WATER PERMIT NO. 6633-3

**SOUTH DAKOTA
WATER PERMIT NO. 6633-3**

Application For Permit To Appropriate Water Within The State Of South Dakota

EAST IRRIGATION POND	
PJ WERDEL & SONS INC.	
NE 1/4, SEC 19, T 109 N, R 70 W	
NE 1/4, SEC 20, T 109 N, R 70 W	
HAND COUNTY	
SETTJE AGRI SERVICES	
AND ENGINEERING, INC.

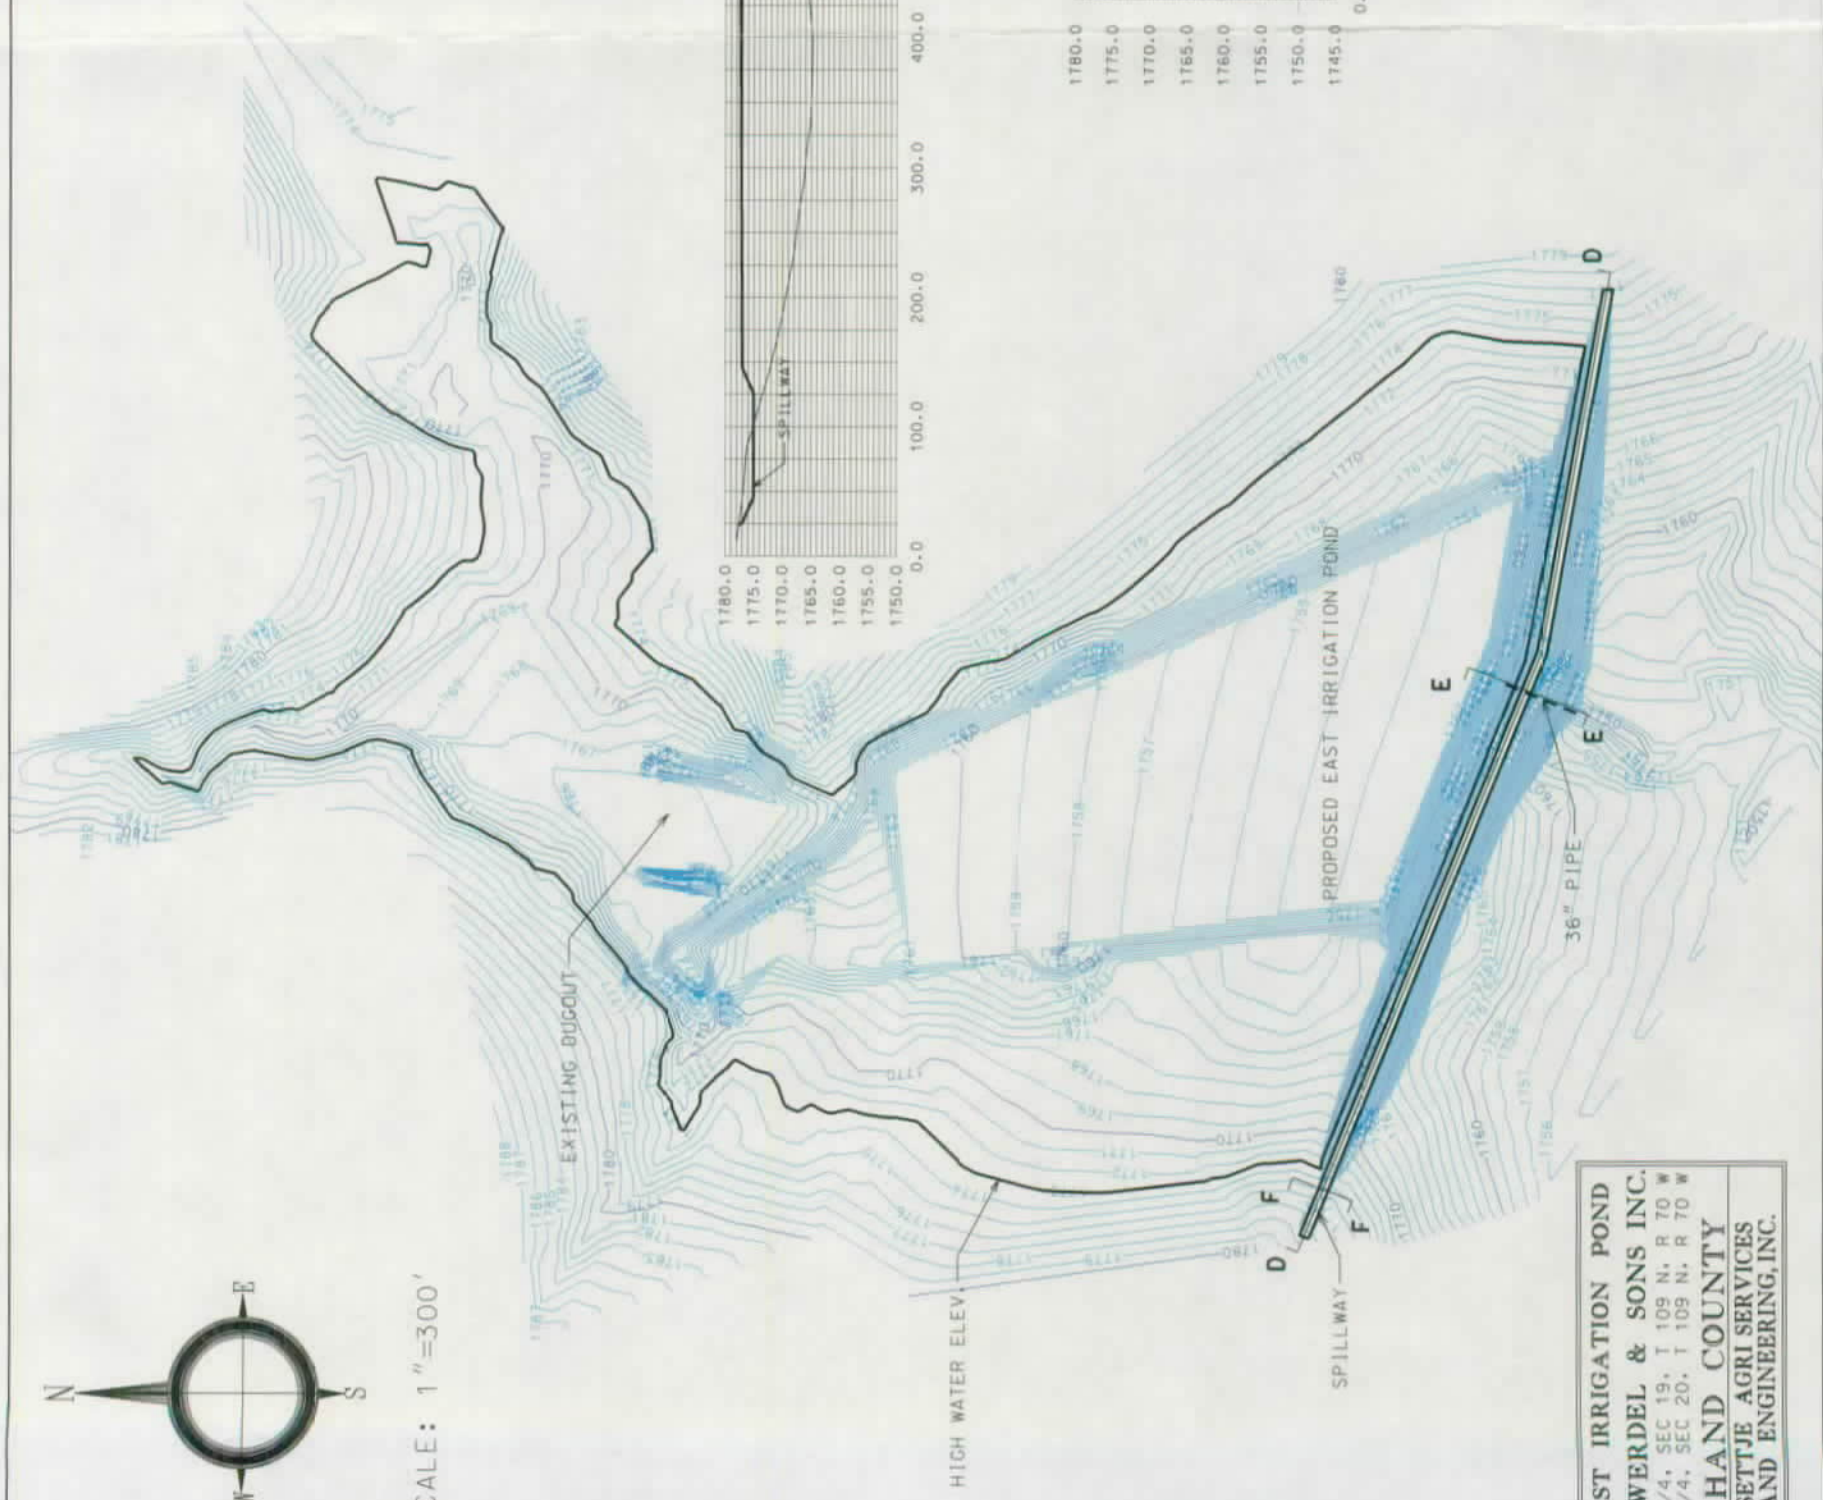
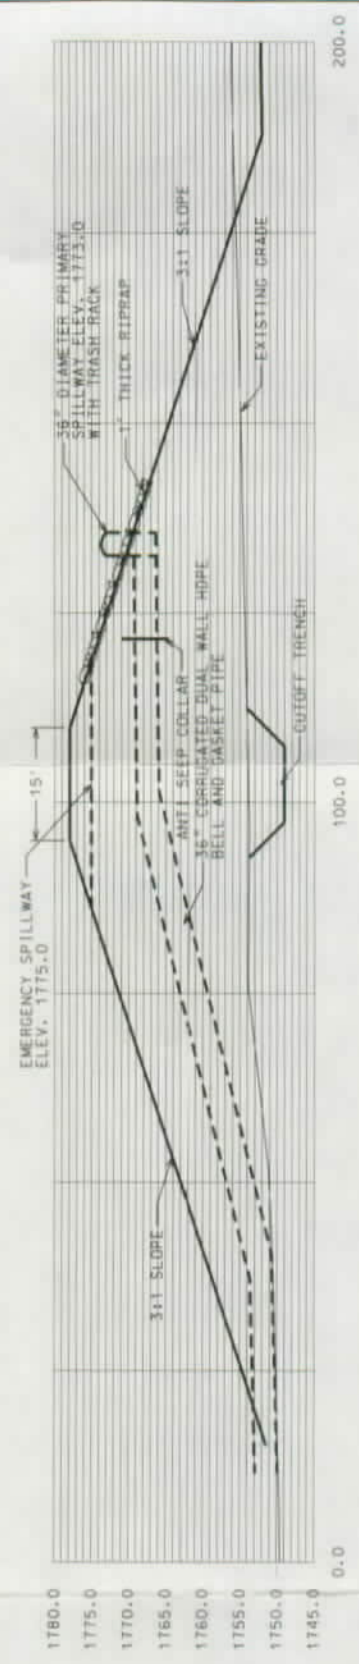
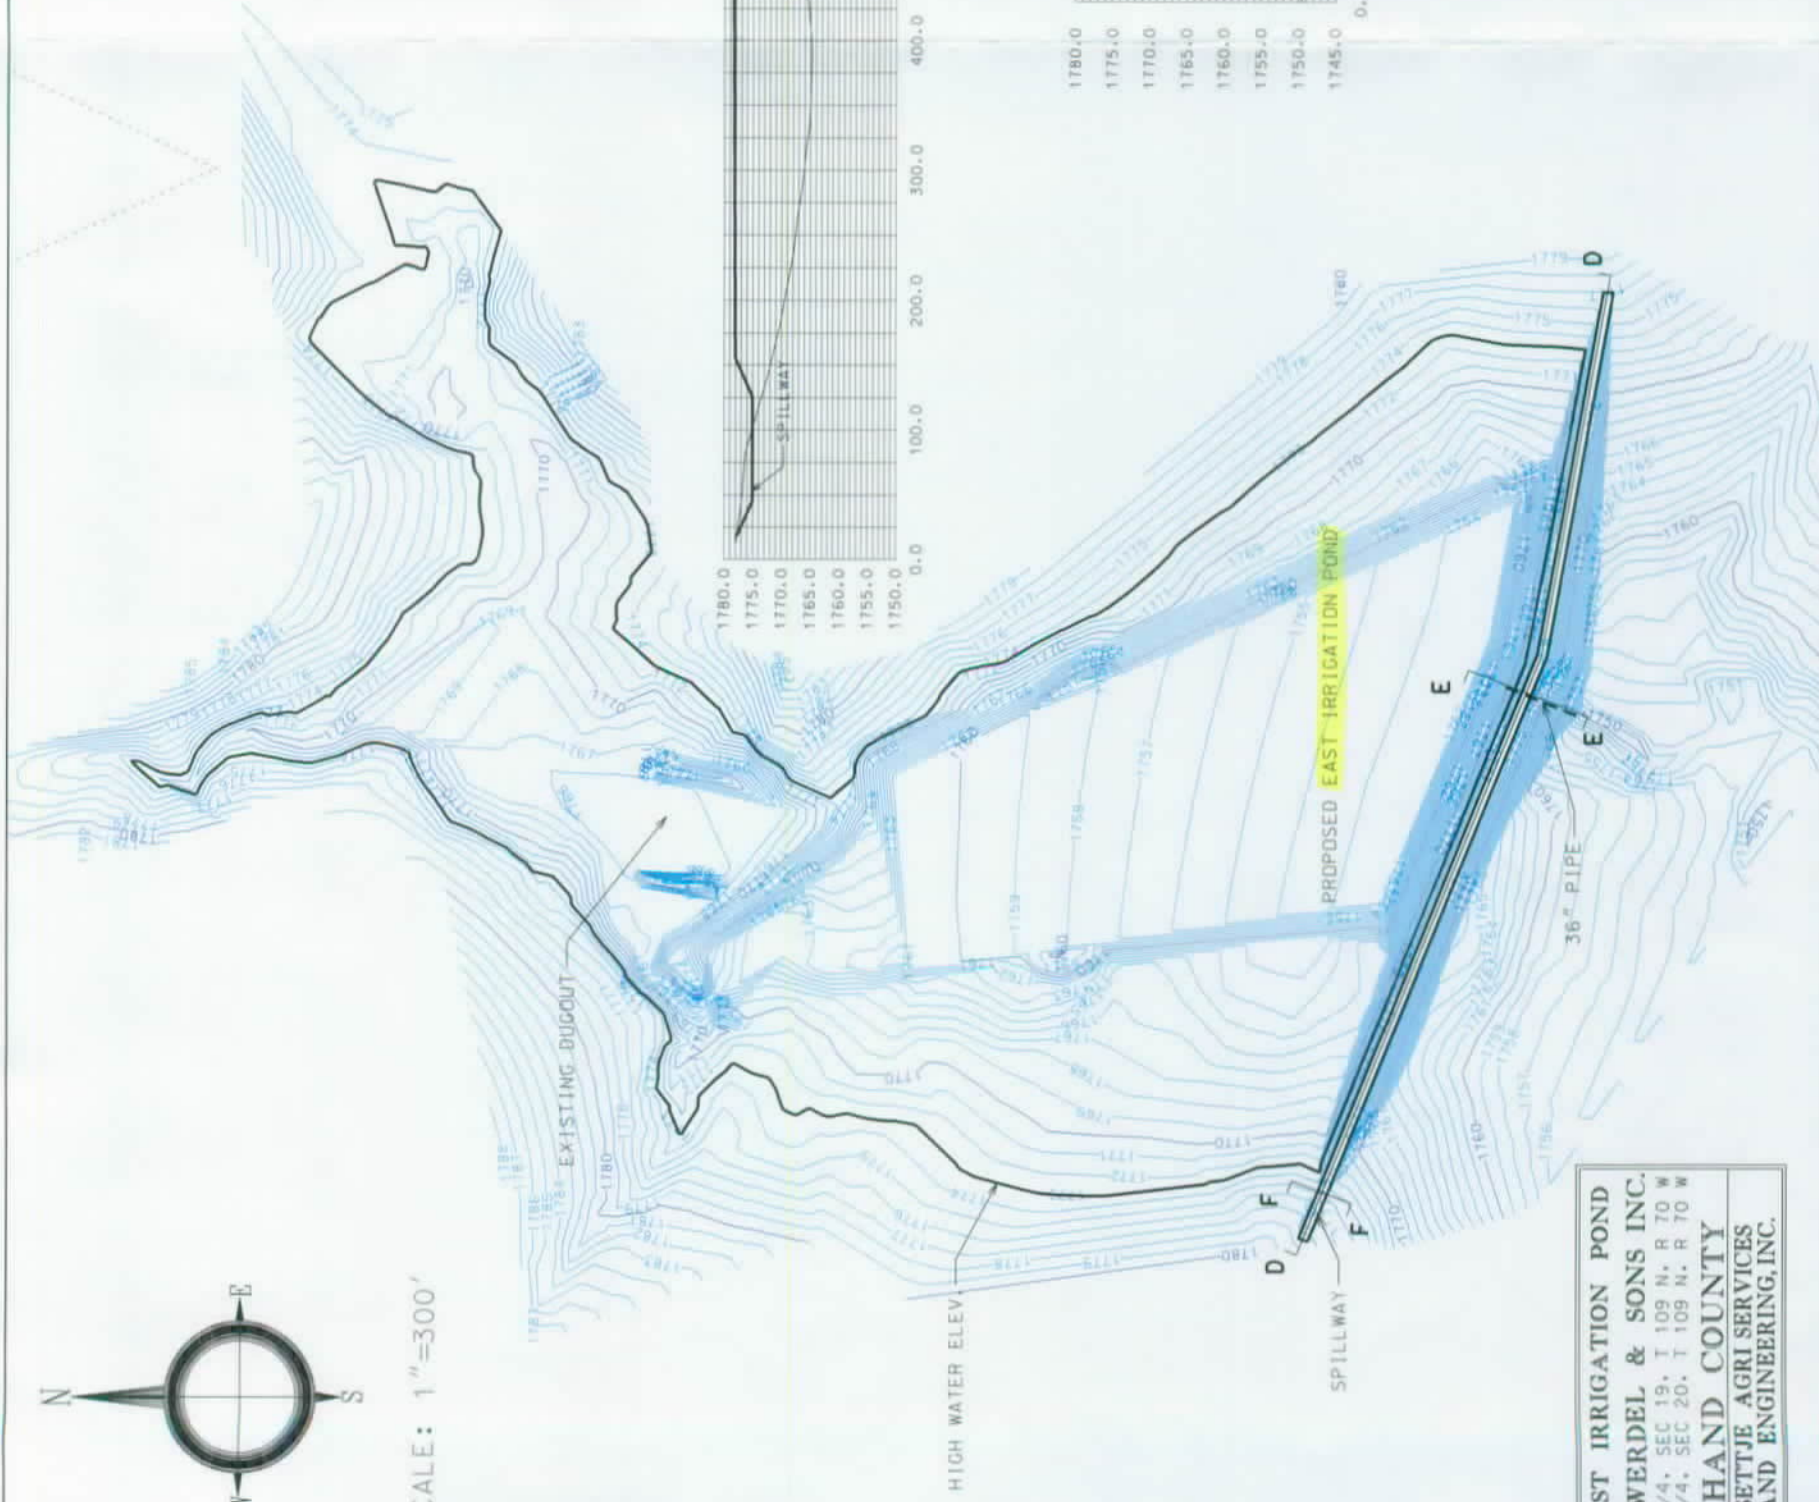
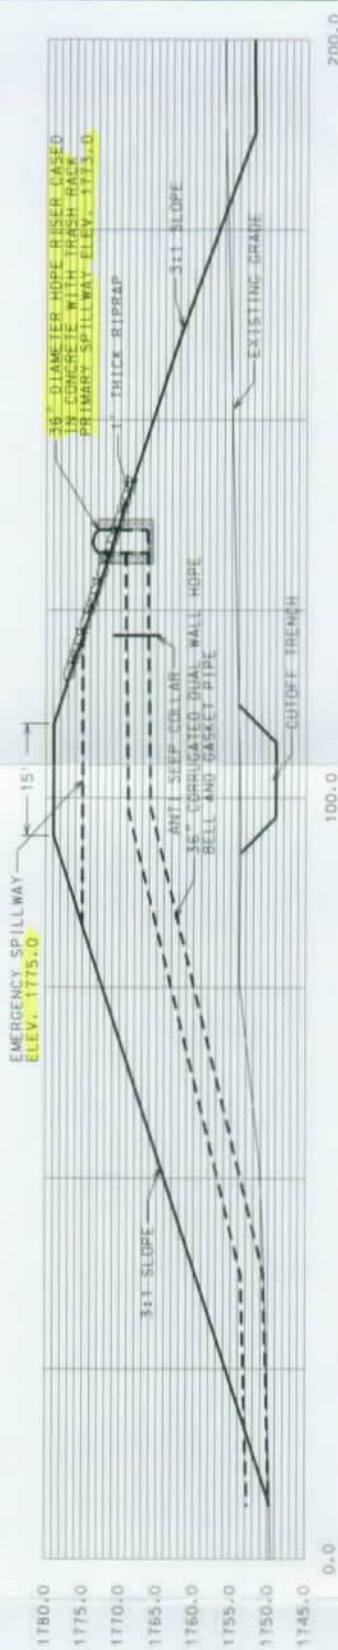
1. In your cover letter dated June 22, 2005 you reference that both dams were designed for 50-year, 24 hour events; however, the Waterway Capacity Calculations data indicates a return period of 25 years was used. You indicated that you thought the calculations were correct and only needed to change the return period figure, however, you would double check the calculations along with sending me copies of your reference material for these calculations.

2. We discussed using 3 feet of freeboard on the emergency spillways for both dams instead of only 2 feet as shown on the plan sheets and stage storage data. Along with that, we discussed the fact that the elevations for top of dam, secondary spillway and primary spillway for the West Dam on the plan sheet Cross Section BB and the elevations used on the stage storage data page do not match up. You indicated the elevations on the stage storage page should be the correct elevations; however, to reflect the 3 foot freeboard change you will need to submit new cross sections and stage storage data for both dams.

3. Instead of using the HDPE pipe as the primary spillway risers, we discussed using a concrete riser on both dams similar to what I see on NRCS designed dams in South Dakota. Enclosed is a copy of a set of NRCS plans illustrating what I would like to see incorporated in your design and shown on the plan sheets. I checked with the NRCS and they get the pre-cast risers from South Dakota Concrete Products in Rapid City (605-343-1450).

1. I have changed the return period to 50 year and the calculations were correct. I have also included a copy of the IDF curves used for the calculations.
2. The spillways for both ponds now provide 3 feet of depth.
3. After talking with South Dakota Concrete Products about their concrete risers, I am not comfortable with the joint from concrete to HDPE or the trash rack that they can provide. Therefore, I have proposed using the HDPE risers with a concrete case poured around them.
4. I have provided cross sections and capacity calculations for the diversion ditch which transfers water over to the west dam.
5. The management of this facility would like to leave the existing dam as it is today to help settle any sediment out before it reaches the new irrigation pond. They will place riprap in the existing spillway to provide erosion protection.
